Access Compliance Report

Public Rights-of-Way

(Pedestrian Signals)

Intersection ID: N/A	Main Street:	Cross Street: N/A	Location: N/A
ADA ID: 9A10B108639A	Signal Type: One Push Button-APS	Overall Compliance: No	Severity Score: BTN 1: N/A BTN 2: N/A No BTN: N/A
Codes/Mitigation Info/Possible Solution		Field Measurements/Component Compliance

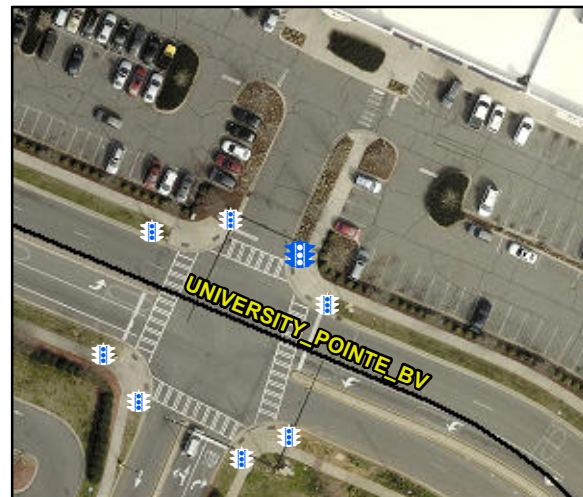
Possible Solutions: Remove & Replace
Replace APS Button With New APS Button.
Remove and Replace Clear Space.

PROW/ADA: R404.2, R404.3, R404.7.2,
R209.1, MUTCD 4e.10
